T21-00002

CITY OF OCEANSIDE ENGINEERING DIVISION	
PRIORITY DEVELOPMENT PROJECT STORM WATER QUALITY MANAGEMENT PLAN FOR 3710 Vista Way Homes	
ENGINEER OF WORK	Please provide signed version ¹
Victor Rodriguez-Fernandez – PE NUMBER 35373

Summary of Comments on Microsoft Word - 2022 V Way PDP SWQMP.docx

VISTA WAY HOMES DMA PLAN

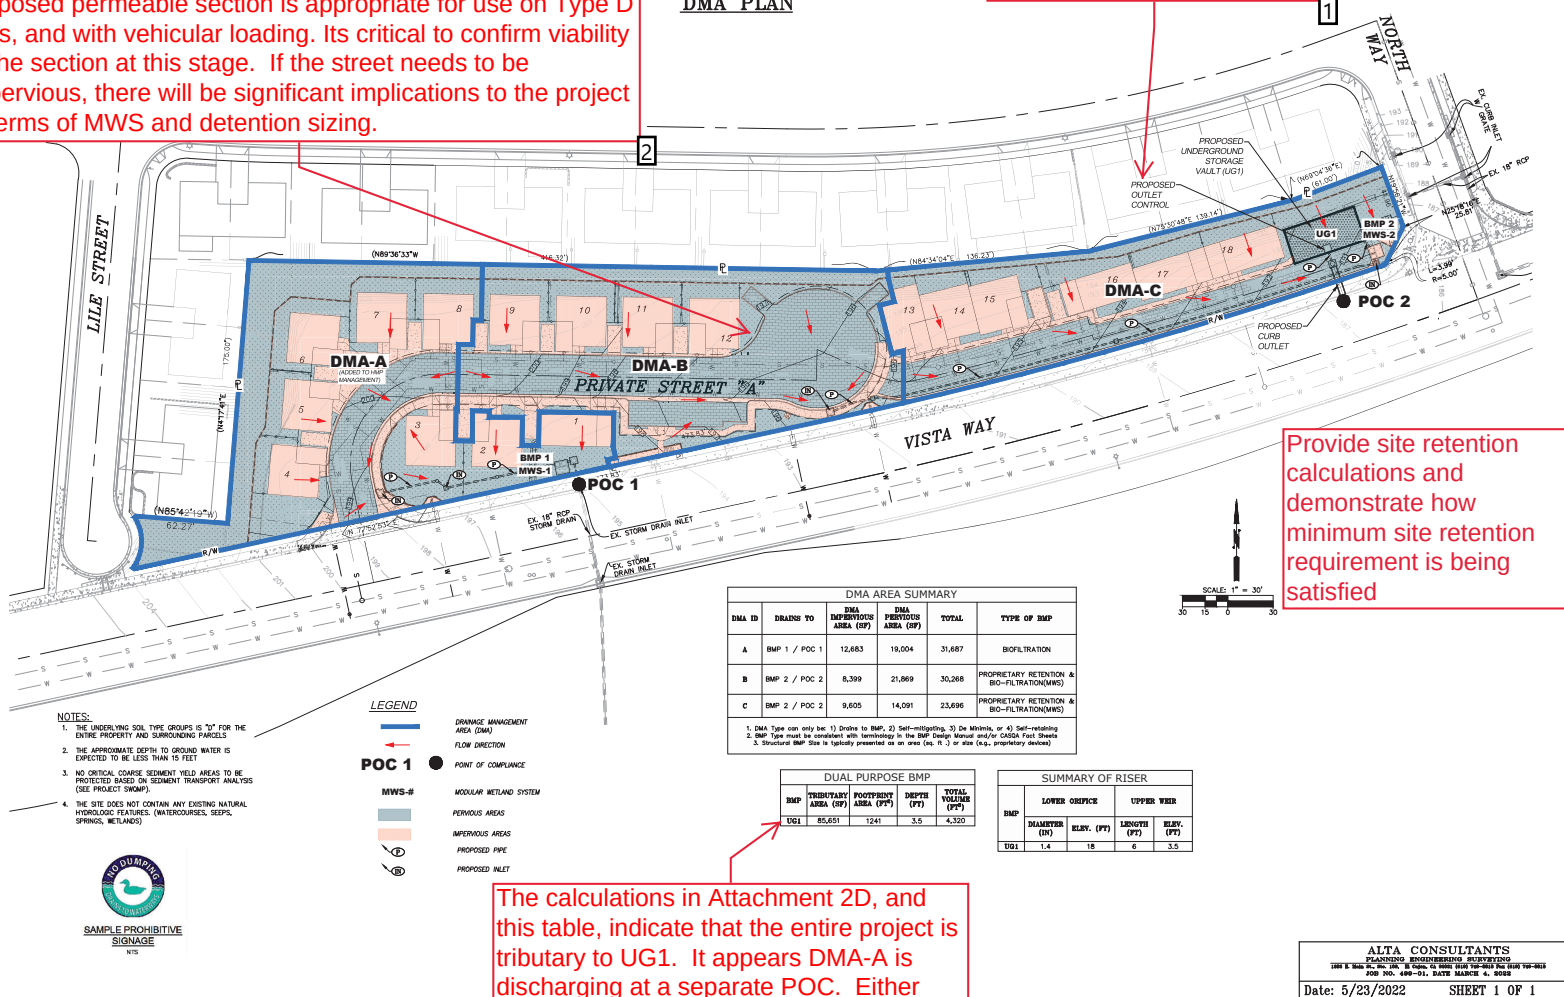
Provide a letter from the soils engineer indicating that the proposed permeable section is appropriate for use on Type D soils, and with vehicular loading. Its critical to confirm viability of the section at this stage. If the street needs to be impervious, there will be significant implications to the project in terms of MWS and detention sizing.

This appears to be inside the detention system how is this maintained?

Provide site retention calculations and demonstrate how minimum site retention requirement is being satisfied

The calculations in Attachment 2D, and this table, indicate that the entire project is tributary to UG1. It appears DMA-A is discharging at a separate POC. Either route DMA-A to UG1 or provide another detention system in DMA-A to address HMP requirements

Automated Worksheet B.1: Calculation of Design Capture Volume (V2.0)

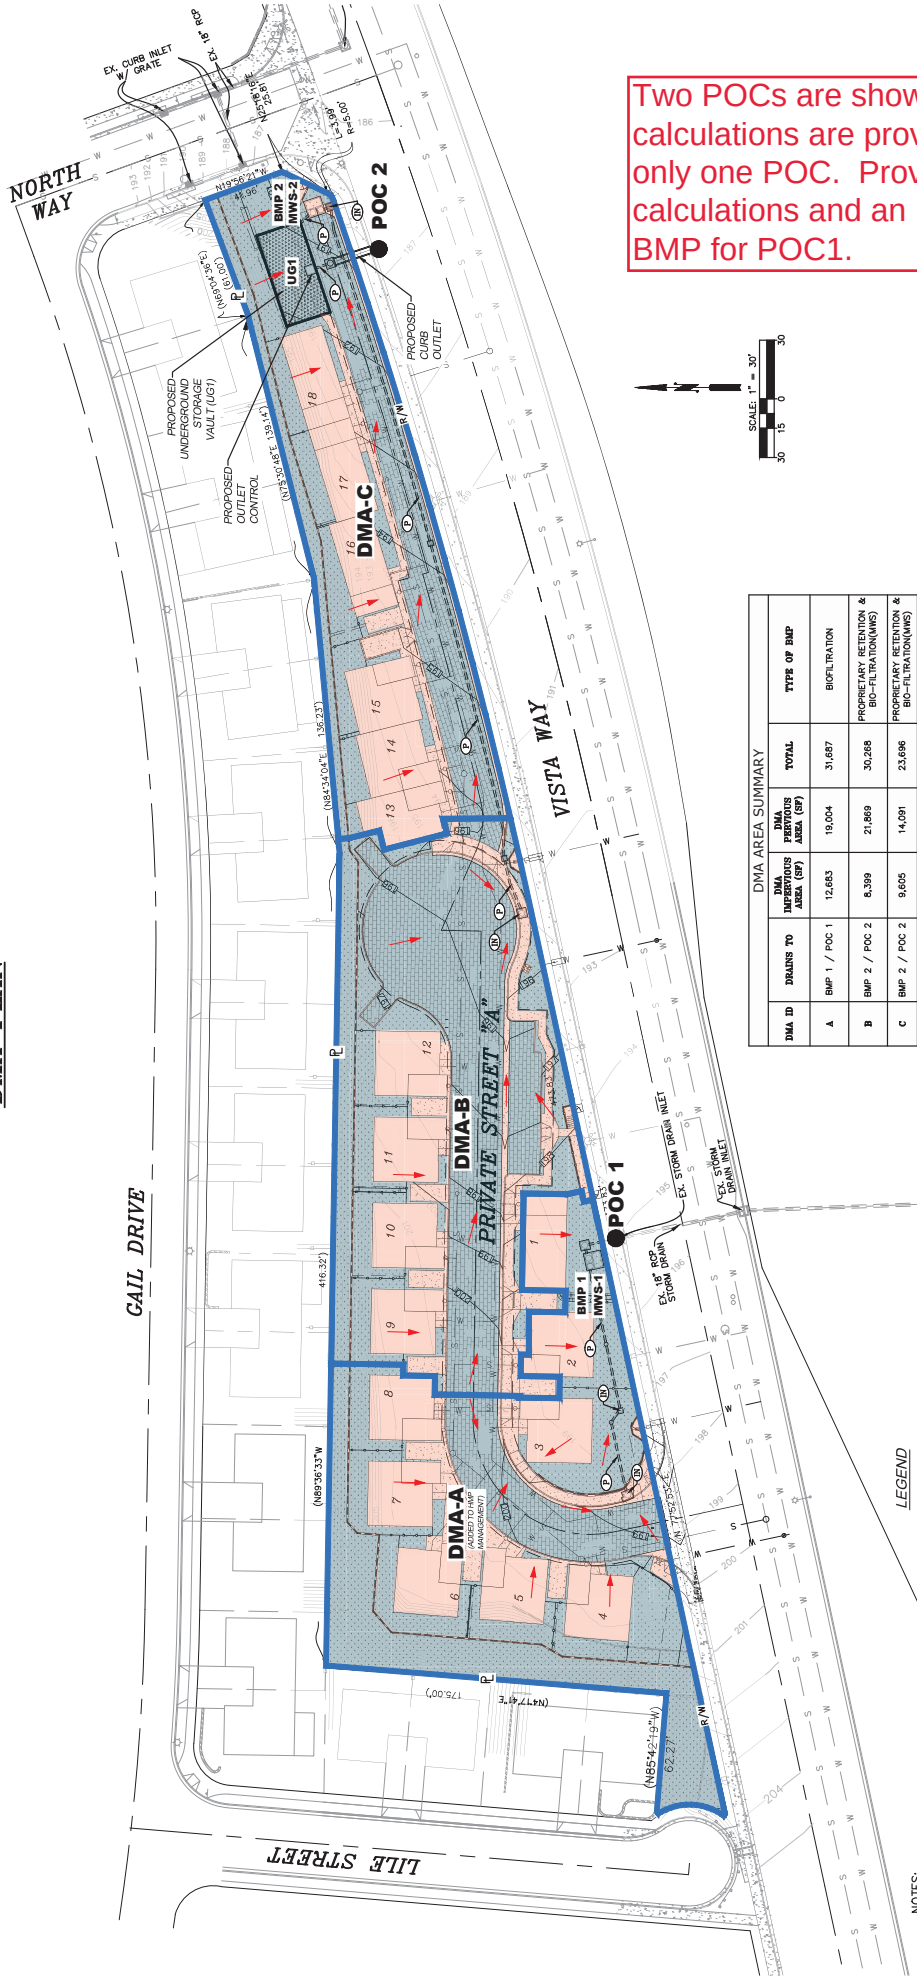
Demonstrate that minimum site retention is provided, use the County of San Diego Automated Stormwater Pollutant Control Worksheets V2.0 to calculate retention volume.

PRIVATE
LANDSCAPE AREA DRAIN DETAIL

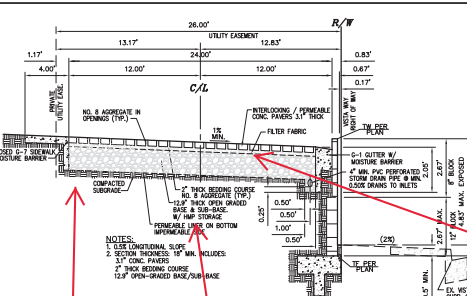
Is this intended to be an HMP BMP?

Provide a letter from the soils engineer indicating that the proposed permeable section is appropriate for use on Type D soils, and with H-20 vehicular loading. Its critical to confirm viability of the section at this stage. If the street needs to be impervious, there will be significant implications to the project in terms of MWS and detention sizing.

Filter fabric will clog, revise section to remove fabric
